ADDENDUM NO. 1

Notice to All Persons and Firms Proposing
to Submit a Bid or Furnish Materials for
2018 ITS Program-Interconnect Camera and Beacon
St. Louis County Project No. AR-1689
Federal Project No. CMAQ-5537(622)

2018 ITS Program-
Interconnect, Camera,
and Beacon Improvements
INTERCONNECT SHEET

SHEET SEQUENCE:
4 OF 20

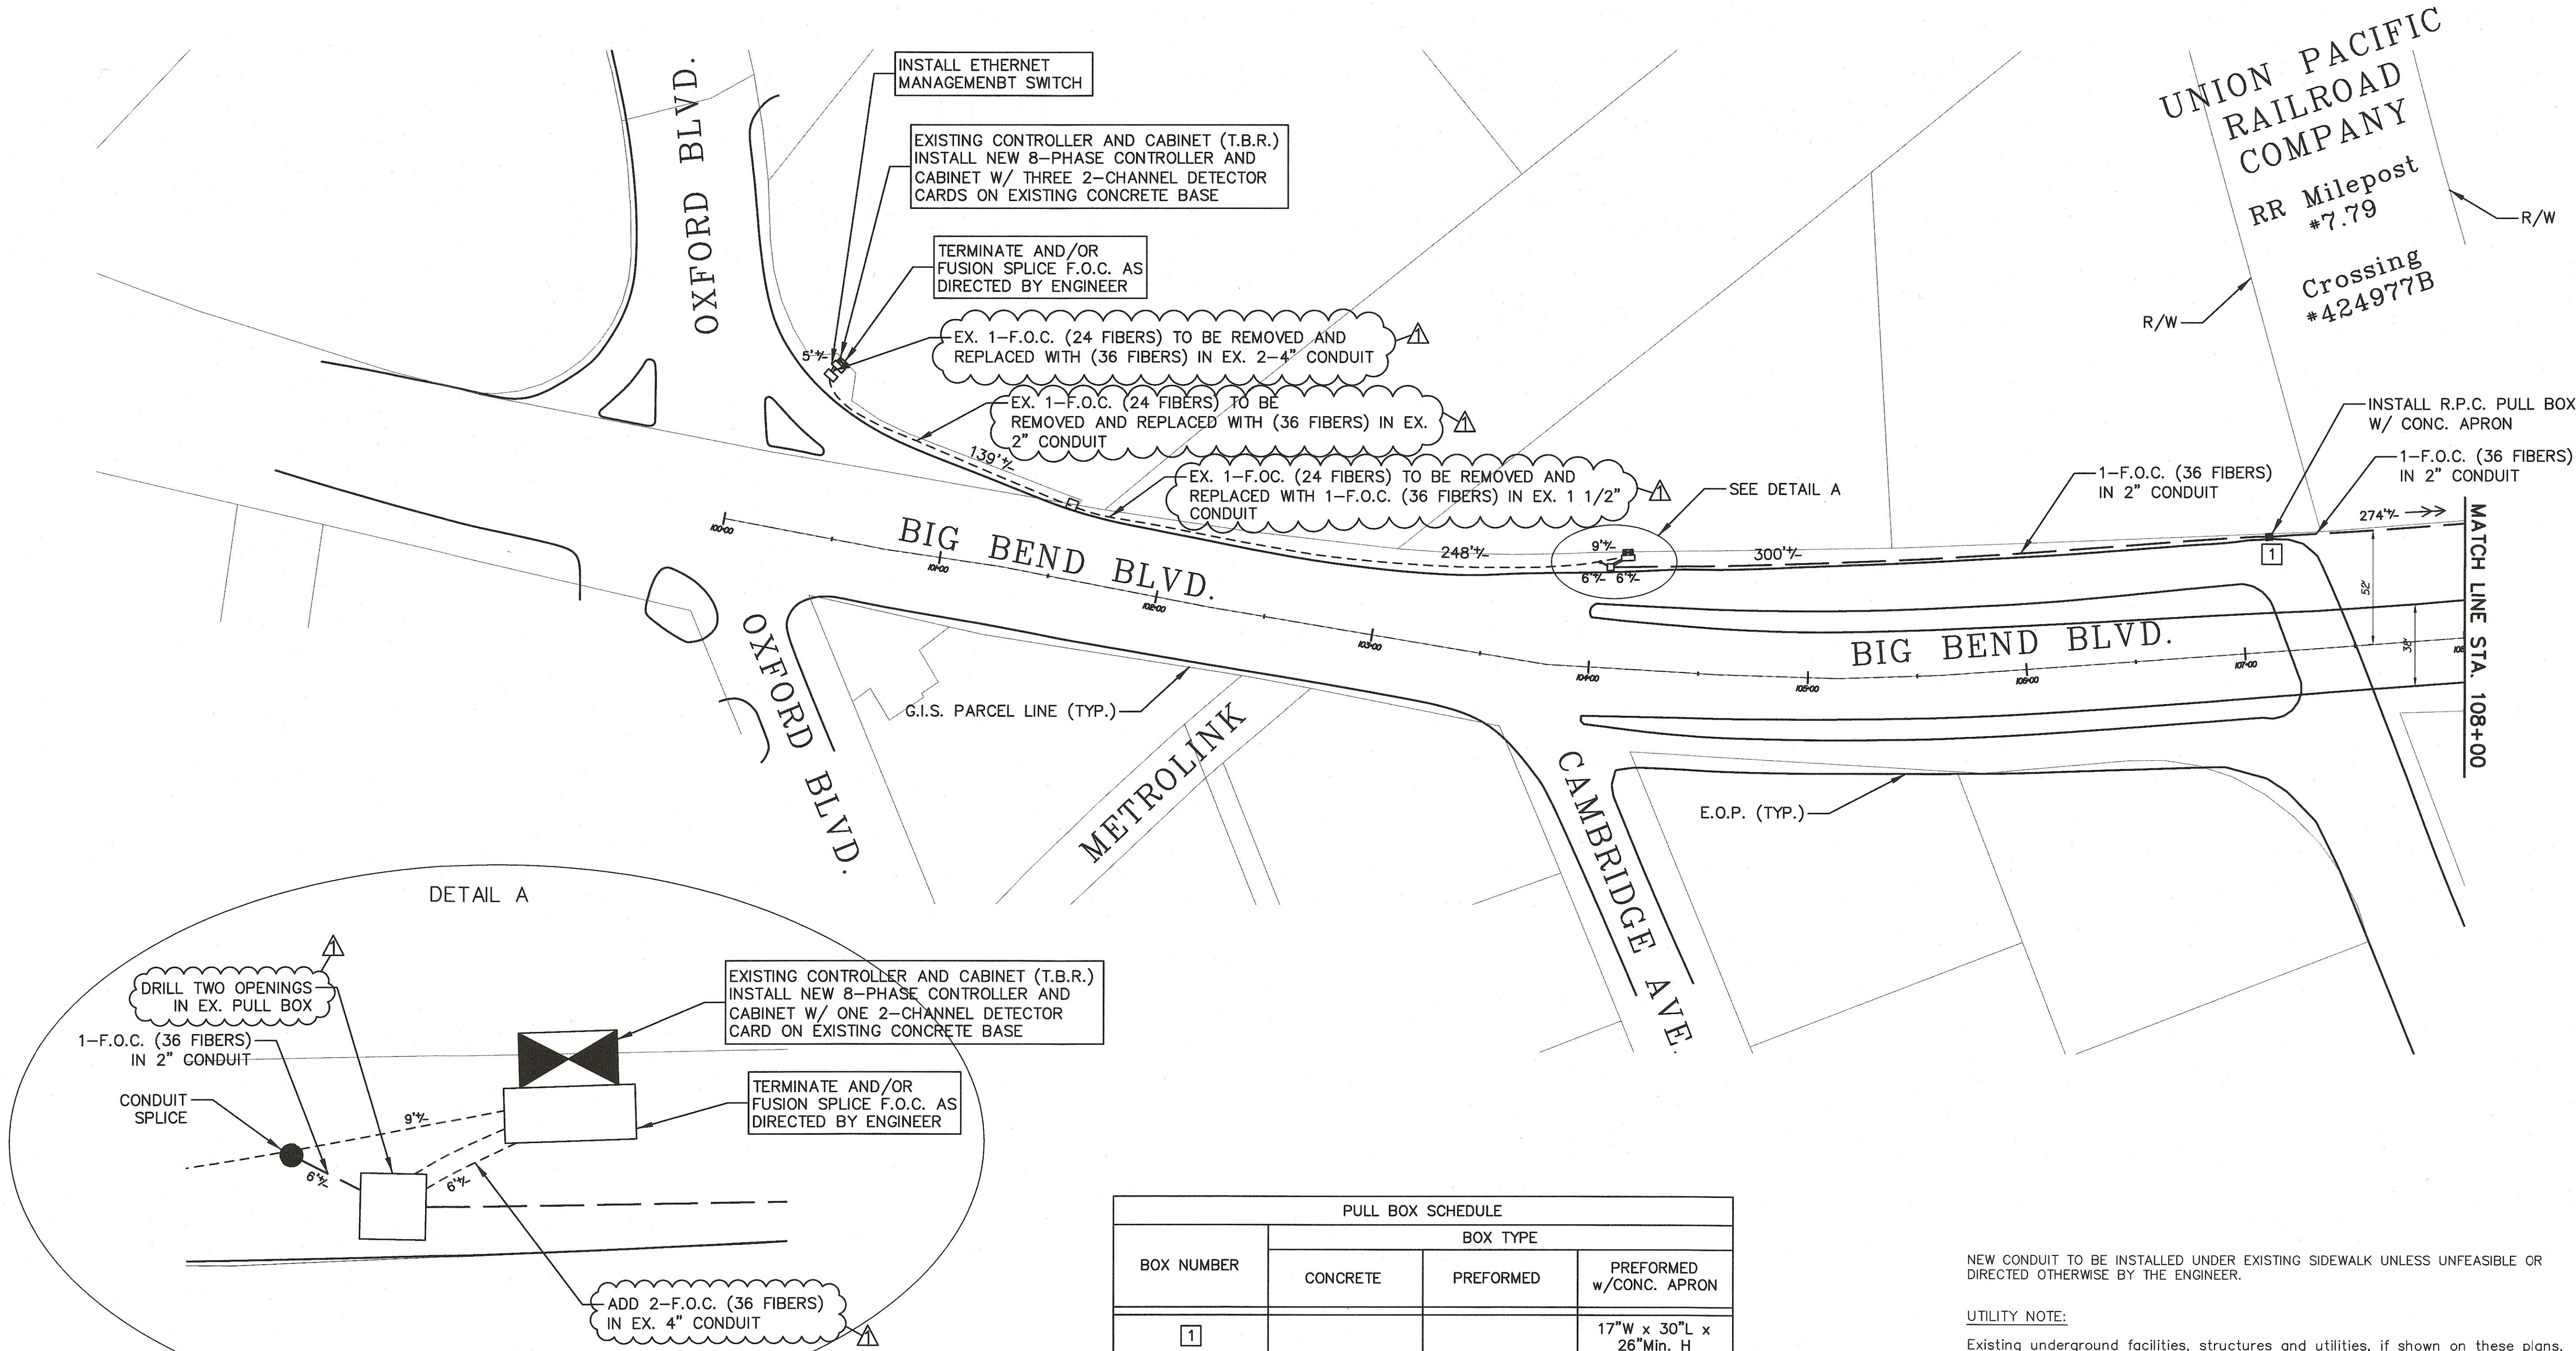
Modified notes on Plan Sheet No. 4 of 20.

NEW CONDUIT TO BE INSTALLED UNDER EXISTING SIDEWALK UNLESS UNFEASIBLE OR DIRECTED OTHERWISE BY THE ENGINEER.
